Re: Submission to SSD-95747716 – 8A, 14 and 16 Buckingham Road, Killara

SJB Planning has been engaged by the owners of 18 Buckingham Road, Killara (No. 18) to review the proposal and prepare a submission. We write to formally object to the proposal.

Figure 2: “wire” frame outline of visual bulk that will be seen from the living area of No. 18. (Source SJB Architects)

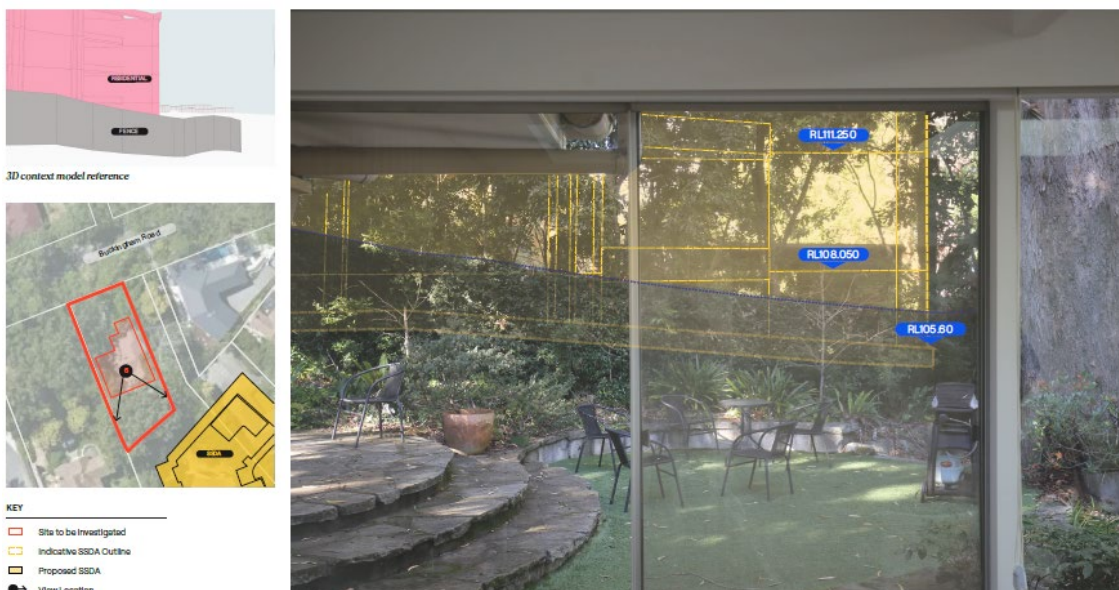
The width of the four (4) storey component of the building directly overlooking No.18 is approx. 39m, approximately double the length of the rear boundary between No. 18 and No. 16 (see Figure 5 below). It is an excessive mass of wall rising to seven (7) storeys. The height, bulk and scale of the proposal is an abrupt and unsympathetic change in scale, footprint and built form when compared to the low density residential development with which it adjoins. There is no adequate attempt to provide a built form transition, instead crudely applying the maximum building height and floor space with little or no analysis of the impacts.

Figure 5: width of the building and direct lines of sight of the built form oriented towards No. 18. Source: underlying architectural drawing DA104 Rev B, BKA Architecture, with additional information included by SJB Planning

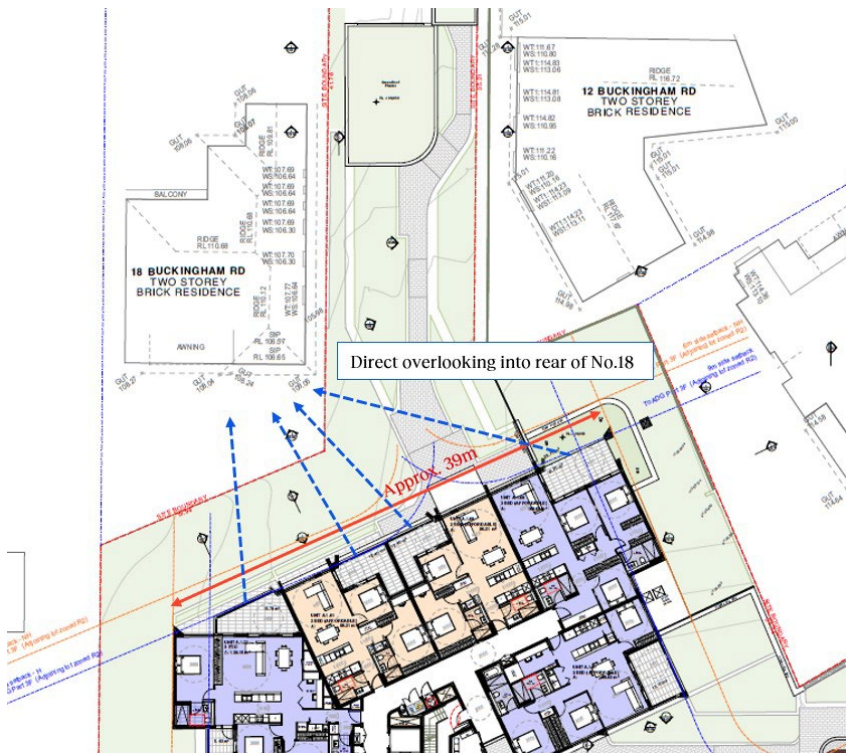
The proposal includes 22 apartments directly oriented to towards the rear garden and living area of No. 18 (see Figure 5 above and Figure 6 below). From the second storey (RL 108.05) to the seventh storey (RL 124.500) there are 20 balconies and living areas with a direct line of site into the rear garden (approx. RL 104-105) and existing floor-to-ceiling glass living room windows (floor level approx. RL 104).

Figure 6: balconies and living areas directly oriented towards the rear of No. 18. (Source: BKA Architecture)

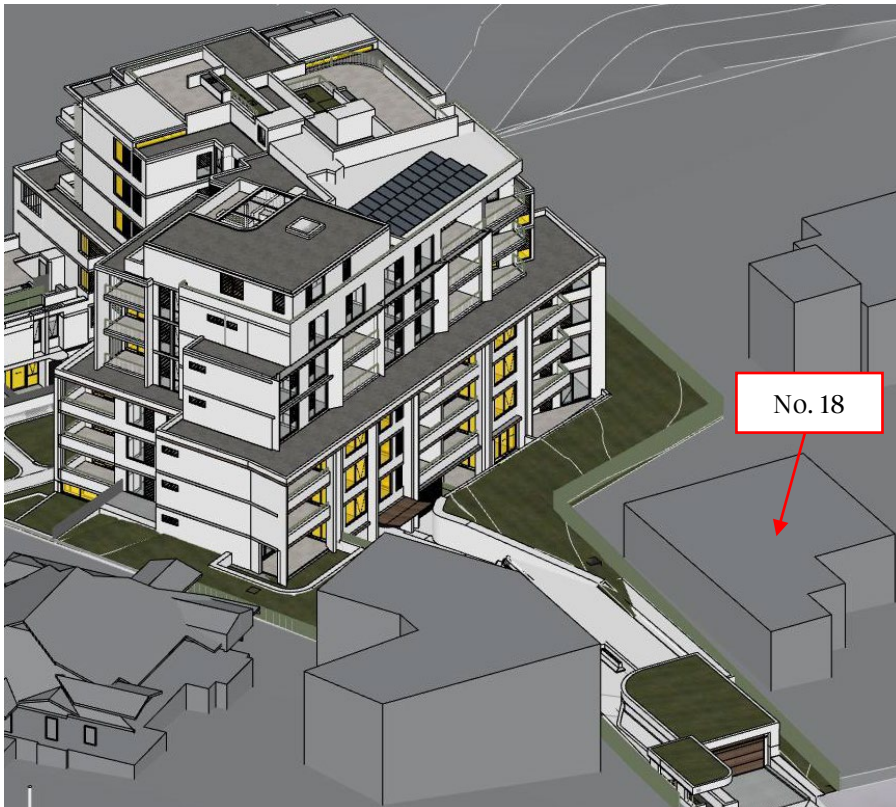
The application documentation, including the EIS, the Visual Impact Assessment and Visual Impact Montages effectively ignore the highly sensitive relationship of the development site with No.18 and the impacts associated with the development.

Figure 13: location of driveway structure immediately adjacent to No 18 (left). (Source BKA Architecture drawing DA012 Rev B and SJB Architecture VIA (right))

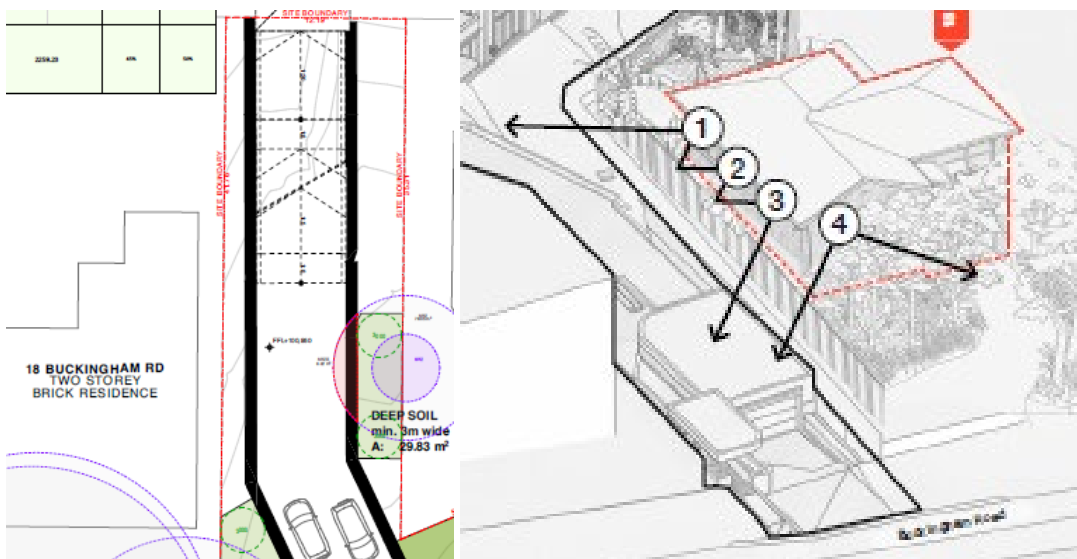
The extent and proximity of the two-way driveway is shown in the extract of the architectural drawing DA012 Rev B below in Figure 13. The location of side boundary windows is also shown.

Unfortunately, the DA documentation has ignored the direct and demonstrable impacts and little or no care has been taken to moderate a transition in the built form directly adjoining No. 18.

Figure 3 – Driveway entrance between 18 and 16 Buckingham Road (prepared by SMART Structures Australia 2026)

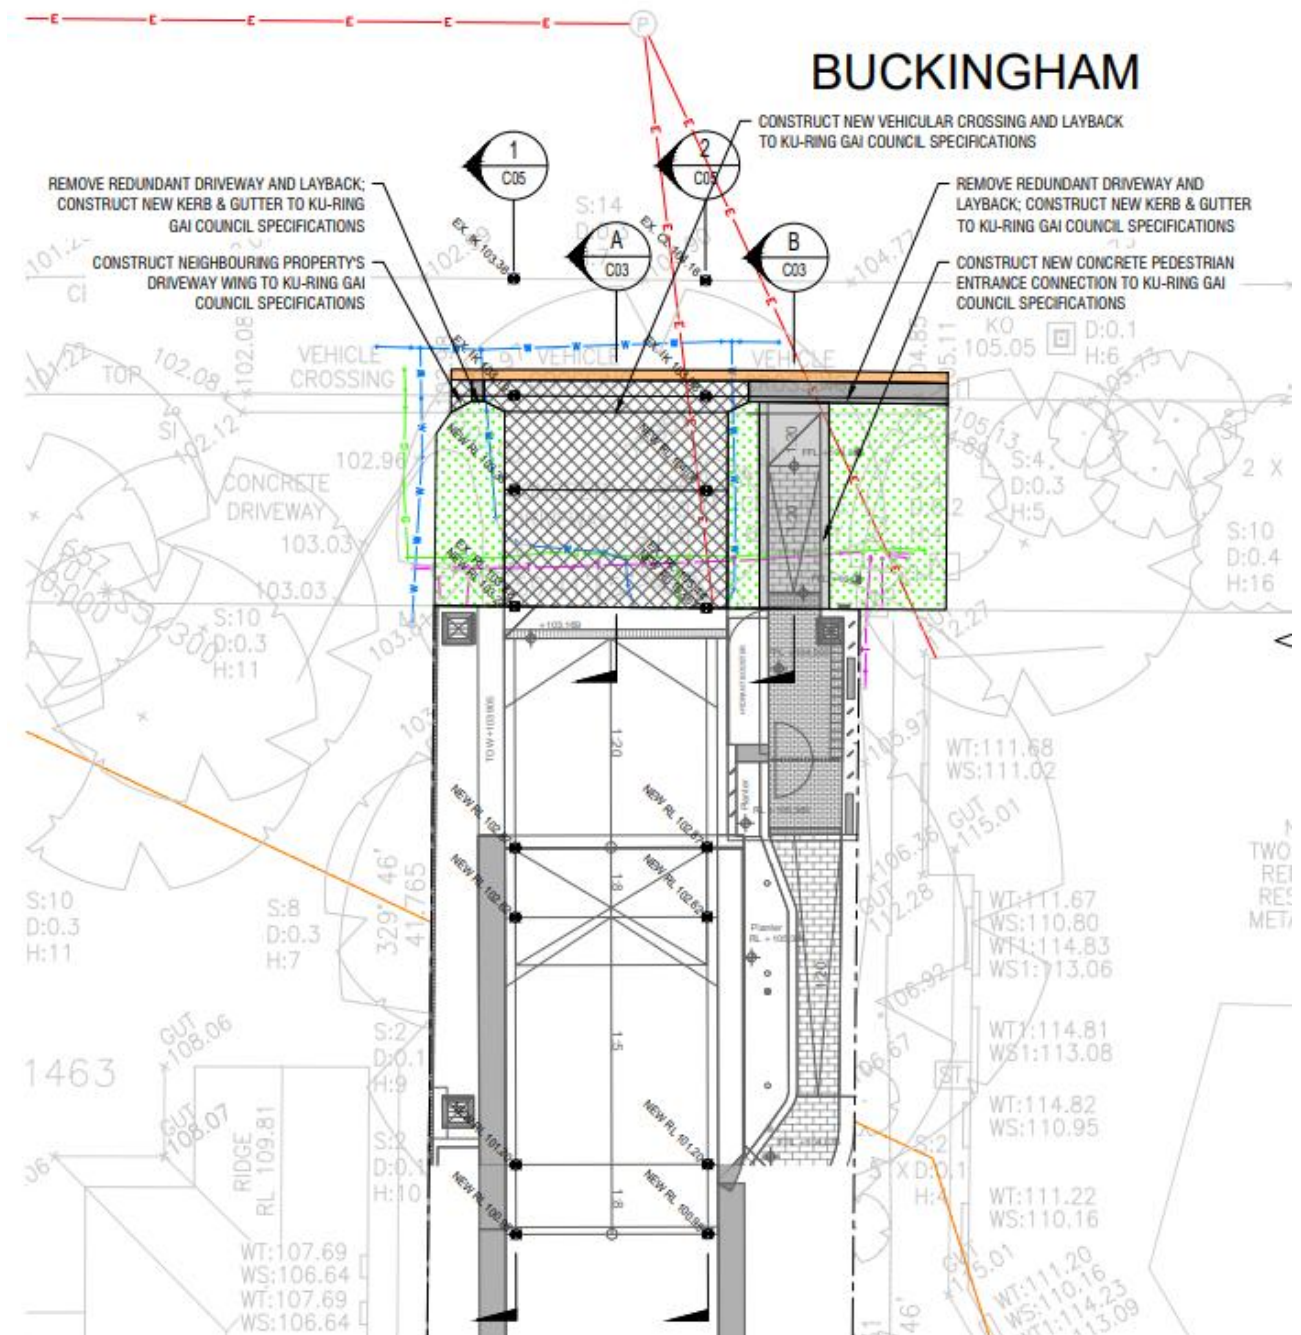
Figure 2 below shows the mapped building footprint, not a development footprint which has not been adequately mapped to demonstrate the full impact of the proposed works. The BDAR Waiver is to clearly show those areas impacted by works and those that are not the development footprint increased to cover the services to be installed.

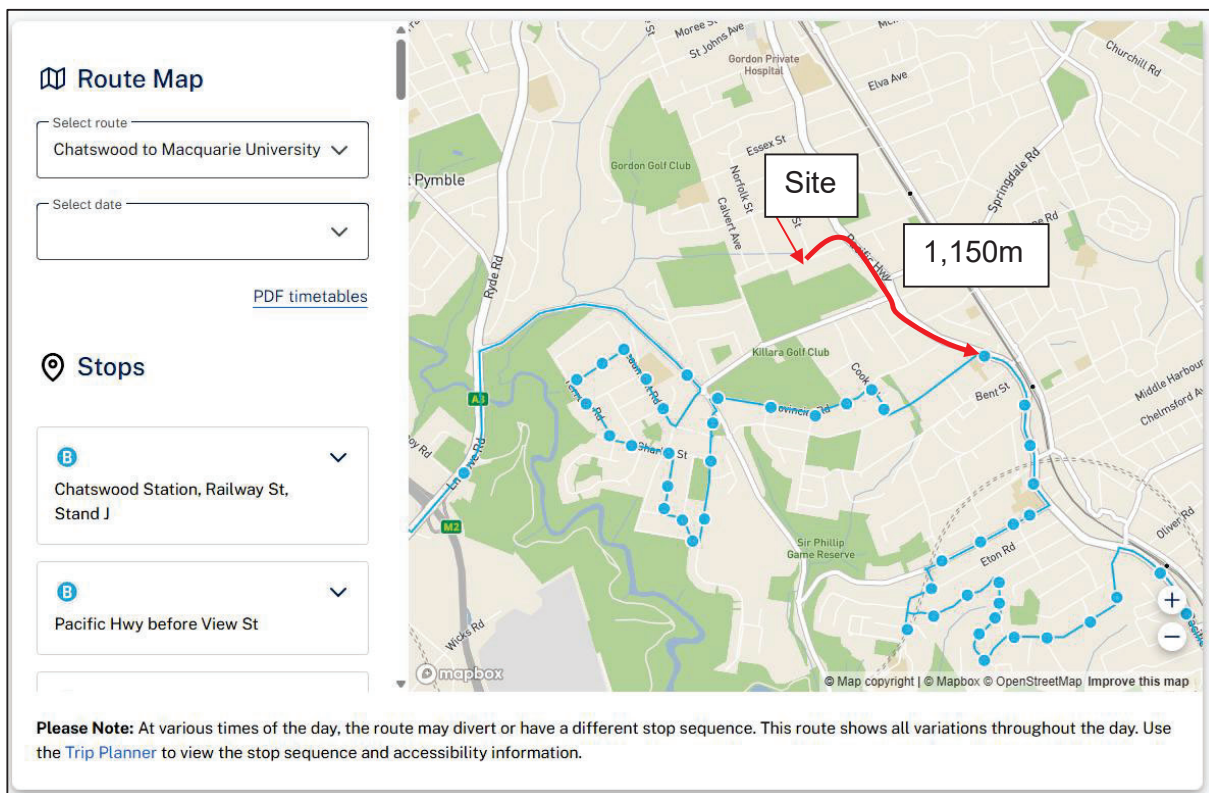
The TIA does not make it clear what the green radius on Figure 3-3 represents. While it is assumed to be an 800m line-of-sight radius, that does not align well with the 400m-800m walking distance reference. Without an exhaustive audit, several of the bus stops shown are outside 1200m walking distance.

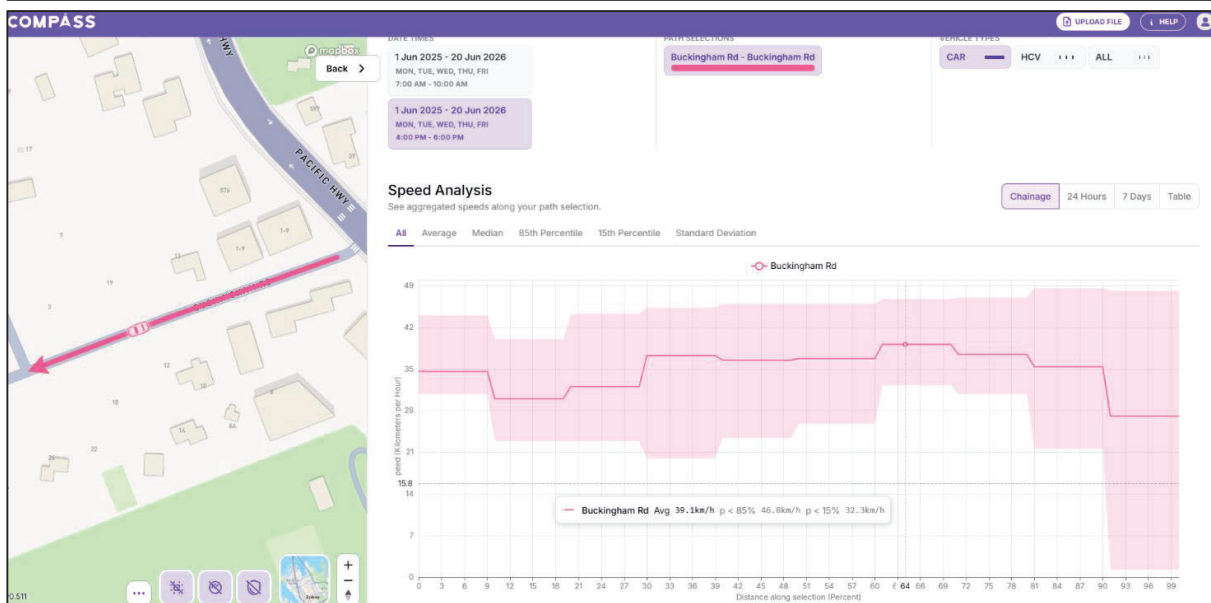
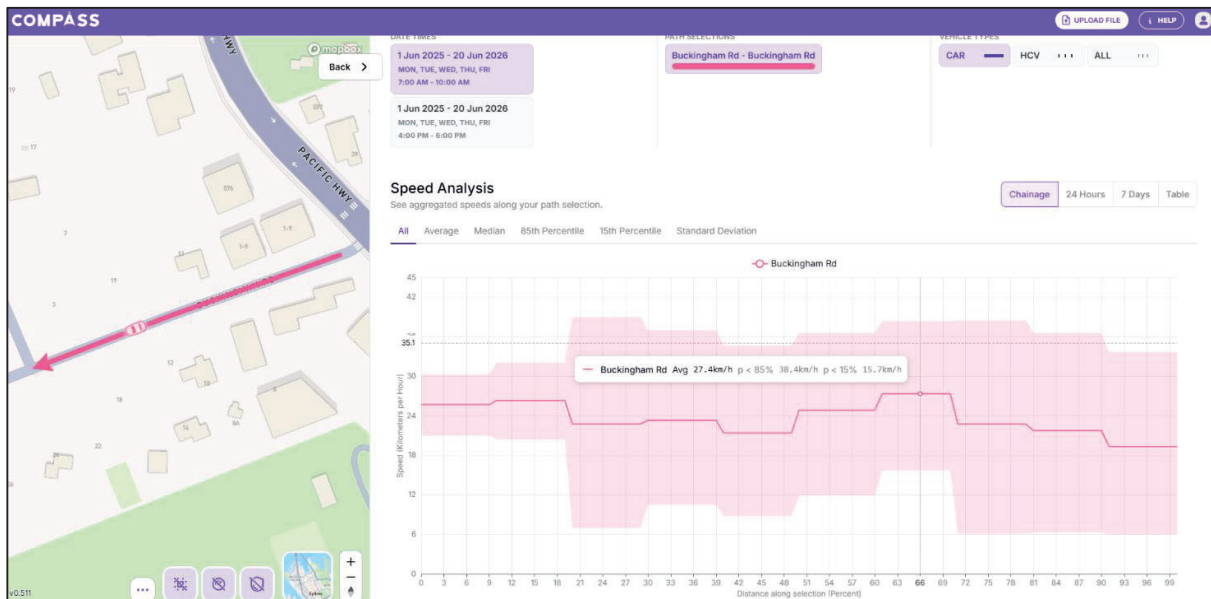
The slope of the frontage road based on the survey plans is 15% between driveways, based on 9.7m RL change over 64.5m. While the Austrroads table does not include correction factors for road that steep, a linear extrapolation provides that an additional 1.0m braking distance should be provided per 1% of downgrade on approach, or approximately 15m additional braking distance to account for slope.

The Buckingham Road eastbound travel speeds were analysed using Compass IOT movement analysis and found that during the AM and PM peak periods the 85th percentile westbound vehicle speeds along the frontage were 38km/h and 47km/h as shown below. Since the design speed is the greater of the speed limit or the 85th percentile, the speed limit of 50km/h should be used for design purposes.

The correct SSD then is $45\text{m} + 15\text{m} = 60\text{m}$. The proposal has shown 13m of SSD which is insufficient and does not comply with AS28980.1. The under provision by 78% is unacceptably unsafe and **cannot be supported on safety grounds in its current design.**
